MEMORANDUM

To: Pittsburgh Penguins et al
From: Hill CDC et al (See attachment A)
CC: Sports and Exhibition Authority
Councilman R. Daniel Lavelle
Date: July 8, 2013
Re: Lower Hill Preliminary Land Development Plan & Specially Planned District

The purpose and intent of this memo is to provide context and a formal response to the Pittsburgh Penguins (Pens) relative to the draft Lower Hill District Preliminary Land Development Plan (PLDP).

Proposed Maximum Building Heights under Penguins' Draft Zoning Text Amendments and PLDP - May 21, 2013

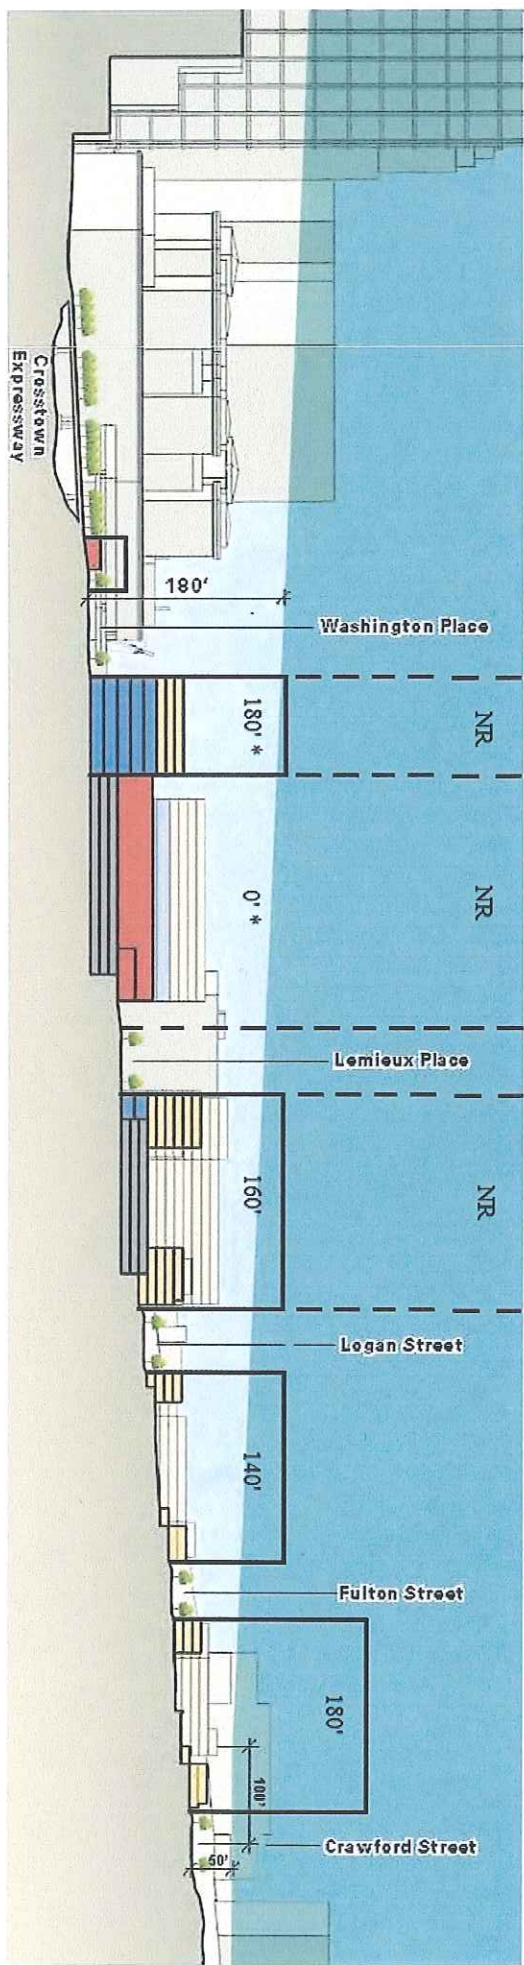
- All development should be subject to the building height standards that were included in previous plans prepared by UDA Architects for the Penguins.
- The proposed SPD text provides for 3 general corridors with different height limitations - a “view corridor” in the middle of the site, and 2 “outside of the view corridor” areas along Bedford Street and along Centre Avenue. The “view corridor” has maximum heights that range from 80 feet on Crawford Street to 180 feet at the lower end of the site. This comes closest to the Penguins' previous assurances, except for the extra 30 feet for buildings on Crawford. The maximum height for buildings on Bedford and on Centre ranges from 160 feet (corner of Bedford and Crawford) or 180 feet (corner of Centre and Crawford) to no height restrictions at all. Most of Bedford and most of Centre would have no maximum height restrictions. This is a significant departure from the Penguins' previous statements.

- The maximum height restrictions in the Lower Hill (both within and outside the “view corridor”) should be changed to comply with the Penguins' prior public statements that views of downtown from Crawford Street would be no more obstructed than they were when the Mellon Arena was standing (see the March, 2010, development plan prepared by UDA). The following maximum height restrictions should be specified in both the Zoning Code text and the PLDP:

* The draft PLDP provides for a 180' maximum building height and urban open space on Centre Avenue, but the proposed zoning text allows unrestricted building height

1. Height Zone II: 180'
 2. Height Zone III: 140'
 3. Height Zone IV: 100'
 4. Height Zone V: 80'
 5. Height Zone VI: 50'
 6. Subdistrict 3: 160' (Consol), 100' (Cambria Suites)
- We would support reasonable and limited exceptions to these height restrictions in return for enforceable commitments to provide inclusionary affordable housing, inclusionary business development, and economic opportunities as outlined in the Hill District Master Plan, such as the following:
